**Administrative Committee of the European Agreement
Concerning the International Carriage of Dangerous
Goods by Inland Waterways (ADN)**

**European Agreement concerning the International Carriage
of Dangerous Goods by Inland Waterways (ADN)****Draft amendments to the Regulations annexed to ADN***

Classification of zones for tank vessels

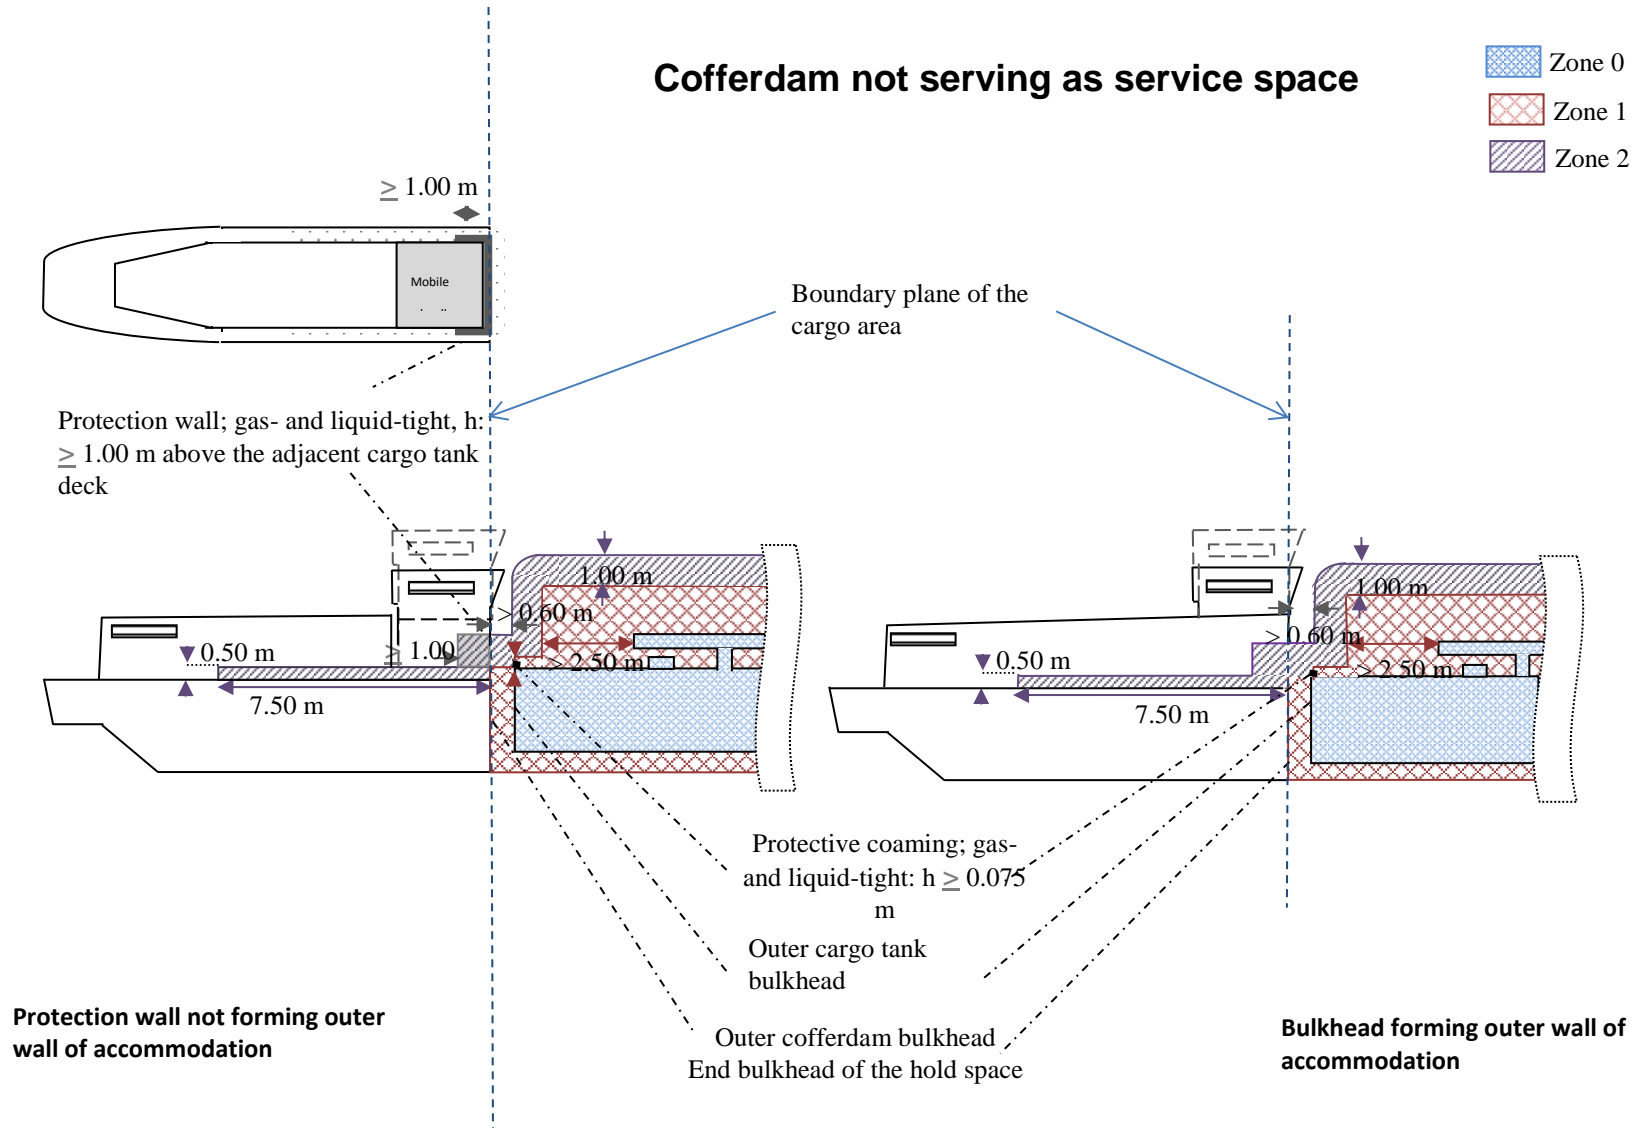
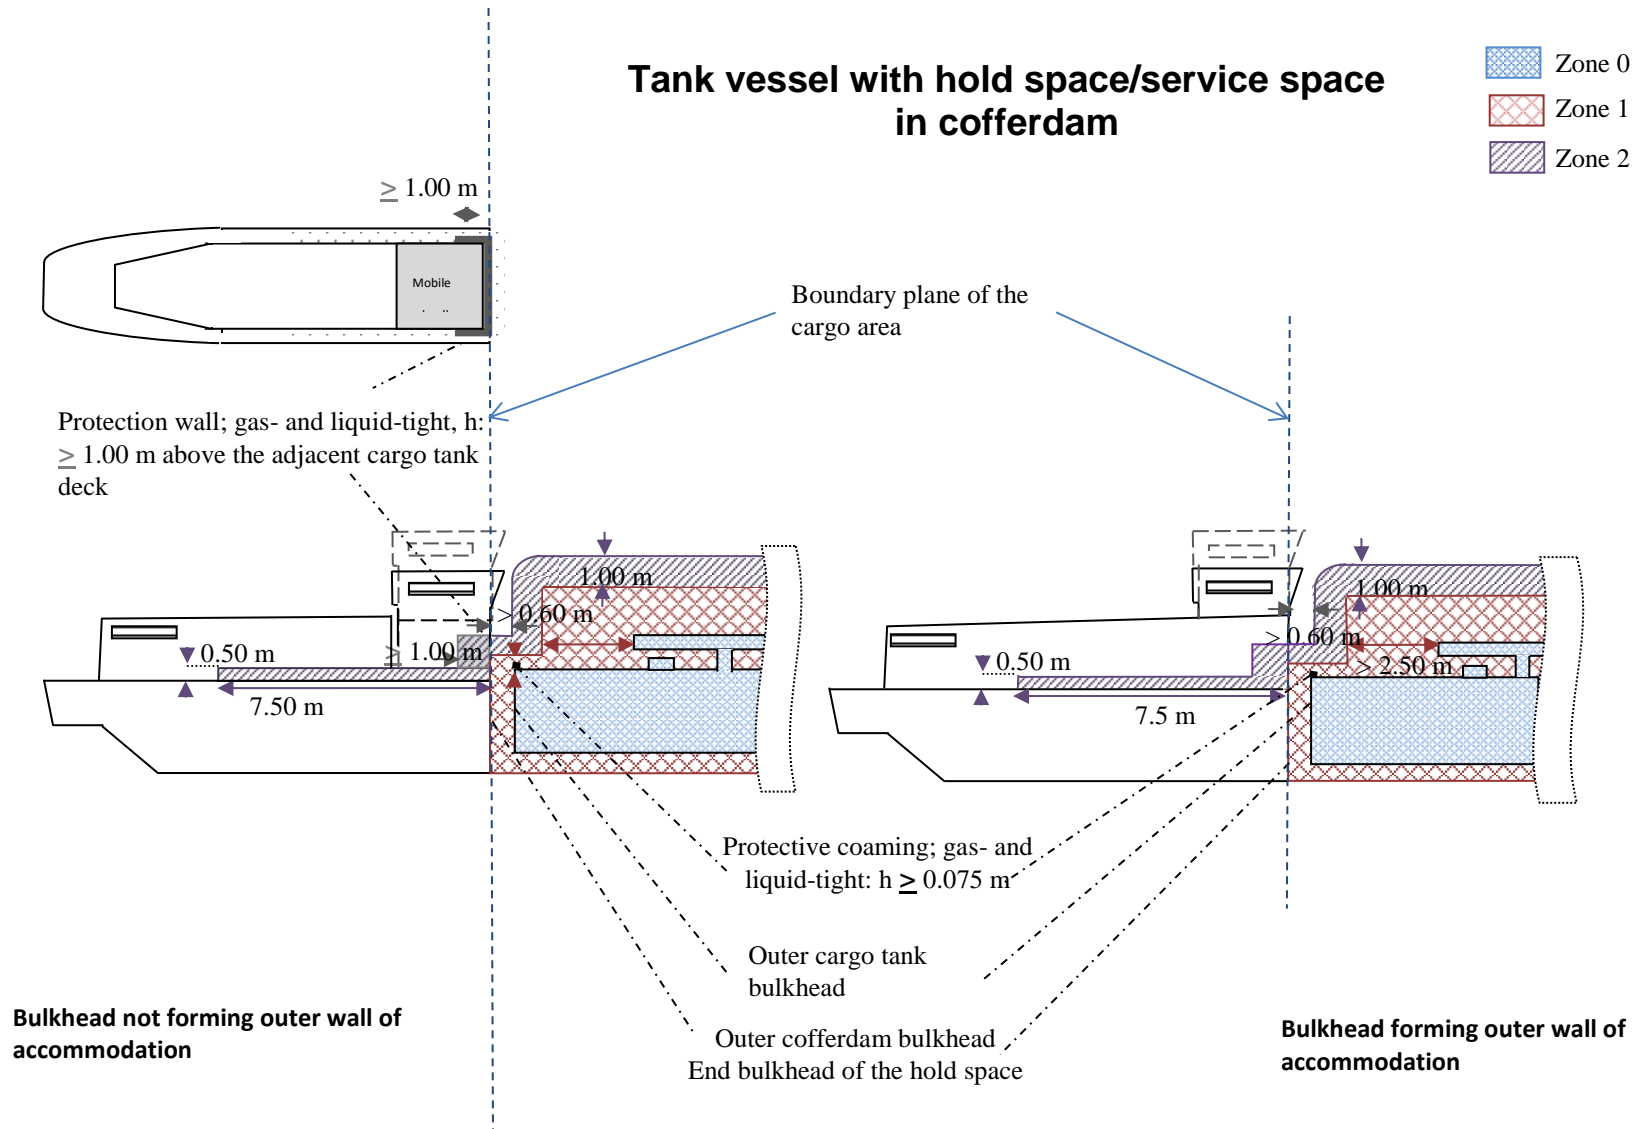
If the ship is built with hold spaces or a cofferdam/part of a cofferdam is arranged as a service space, the adjacent height (fore and aft) to the “boundary plane of the cargo area” is 1.00 m above deck (see diagram).

Zone 2 comprises:

- On the deck in the cargo area, a zone extending 1.00 m upwards and sideways longitudinally from zone 1.
- On the fore deck and the aft deck, an area 7.50 m in length across the entire width of the vessel and adjacent to the “boundary plane of the cargo area”. Between the lateral side of the vessel and the protection wall, the length and height of this area equals the dimensions of the lateral side of the protection wall. Elsewhere, the height in zone 2 is 0.50 m.

This area is not part of zone 2 if the protection wall extends from one side of the vessel to the other and there are no openings.

Figure 2.2.8.1.6.1: Step-wise approach to classify and assign packing group of corrosive mixtures

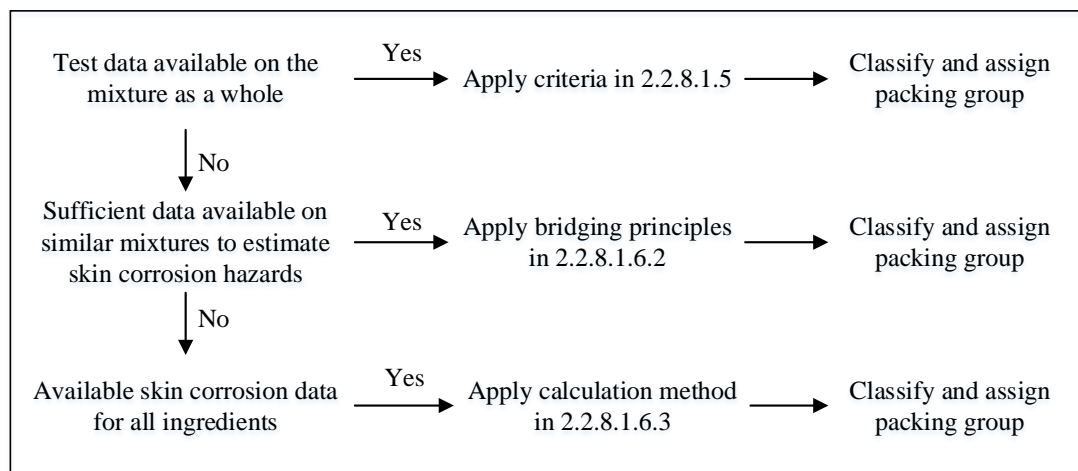
For mixtures it is necessary to obtain or derive information that allows the criteria to be applied to the mixture for the purpose of classification and assignment of packing groups. The approach to classification and assignment of packing groups is tiered, and is dependent upon the amount of information available for the mixture itself, for similar mixtures and/or for its ingredients. The flow chart of Figure 2.2.8.1.6.1 below outlines the process to be followed:

Figure 2.2.8.1.6.3: Calculation method

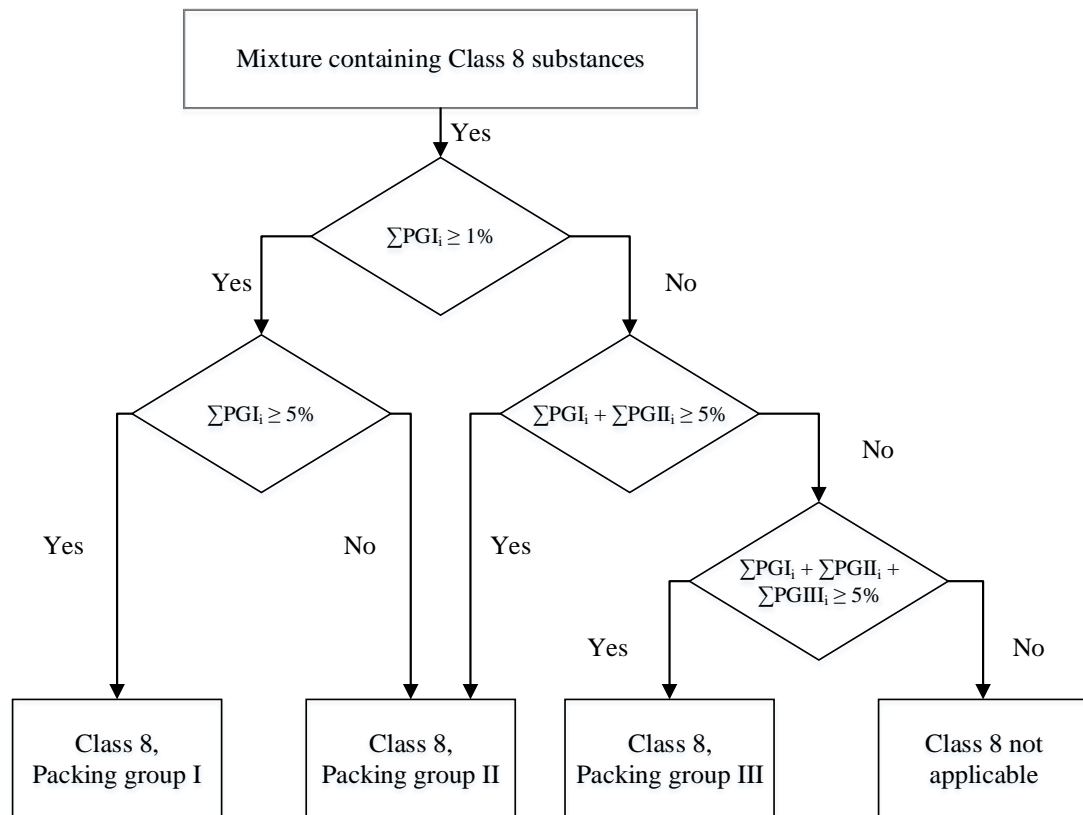
2.2.8.1.6.3.3 To determine whether a mixture containing corrosive substances shall be considered a corrosive mixture and to assign a packing group, the calculation method in the flow chart in Figure 2.2.8.1.6.3 shall be applied.

2.2.8.1.6.3.4 When a specific concentration limit (SCL) is assigned to a substance following its entry in Table A of Chapter 3.2 or in a special provision, this limit shall be used instead of the generic concentration limits (GCL). This appears where 1% is used in the first step for the assessment of the packing group I substances, and where 5% is used for the other steps respectively in Figure 2.2.8.1.6.3.

The criterion for a packing group is fulfilled when the result of the calculation is ≥ 1 . The generic concentration limits to be used for the evaluation in each step of the calculation method are those found in Figure 2.2.8.1.6.3.
